Wisconsin Department of Transportation

Proposal #22: 1190-05-75
Chippewa Falls – New Auburn
CTH B – STH 64 (North and South Bnd)
USH 53
Chippewa County

This is Addendum No. 01, which provides for the following:

ADDENDUM NO. 01

Addendum No. 01
ID 1190-05-75
Revised Sheet 3
February 5, 2016

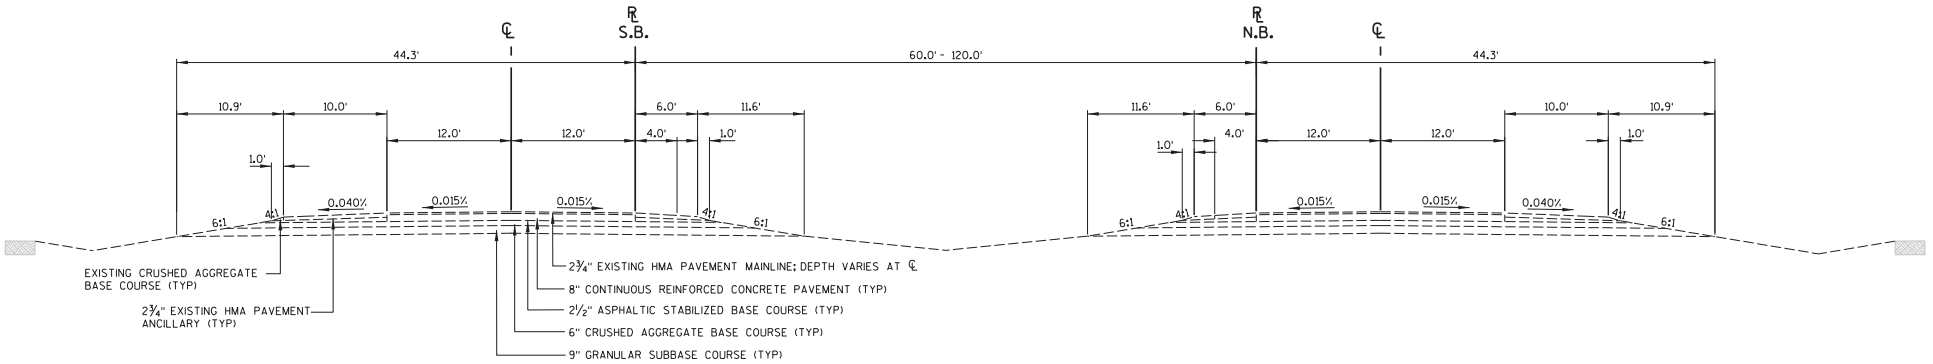
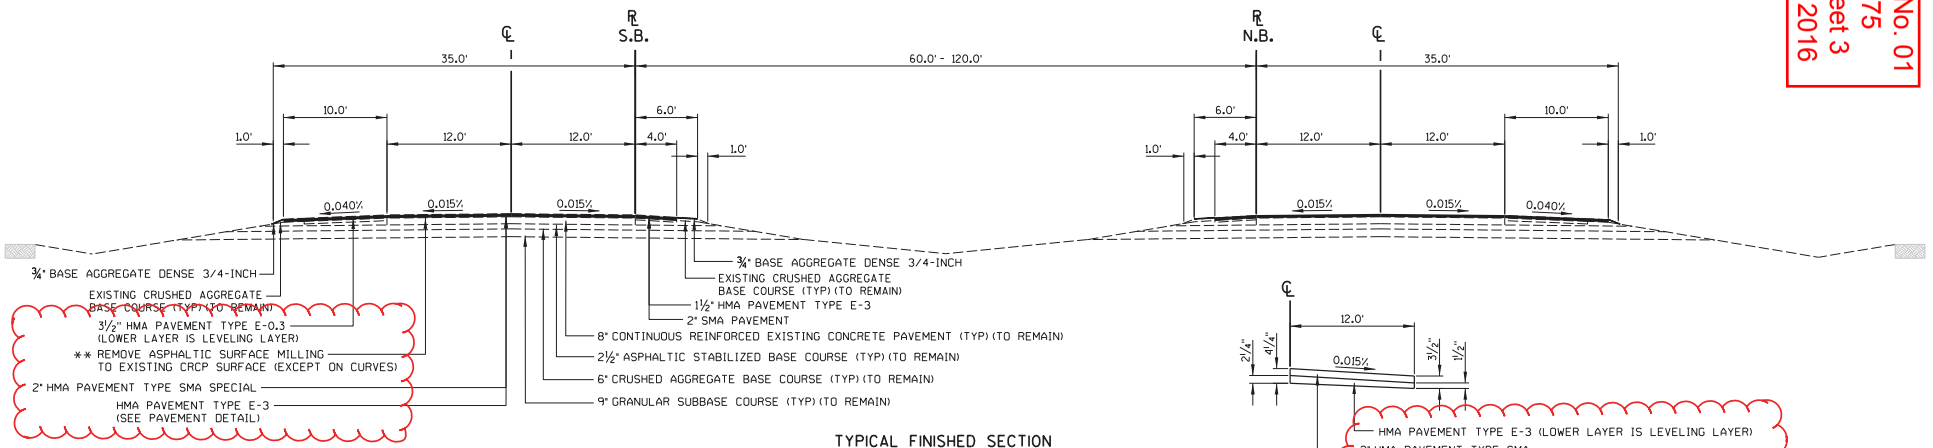
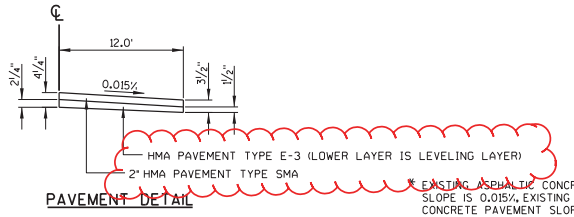
Revised Plan Sheets	
Plan Sheet	Plan Sheet Title (brief description of changes to sheet)
3	Typical Sections - Revised Note to show HMA and E-0.3 lower layer is a leveling layer
9	Construction Details – Revised Concrete Pavement CL Repair Detail
49	Misc. Quantities – Revised Asphaltic Surface Patching Quantity
50-51	Misc. Quantities – Revised Culvert Pipe Items
52	Misc. Quantities – Revised Items For Curb Repair, Culvert Markers, Reconstructing/Adjusting Inlets
60-62 64-69	Plan Sheets – Revised Culvert pipe item notes
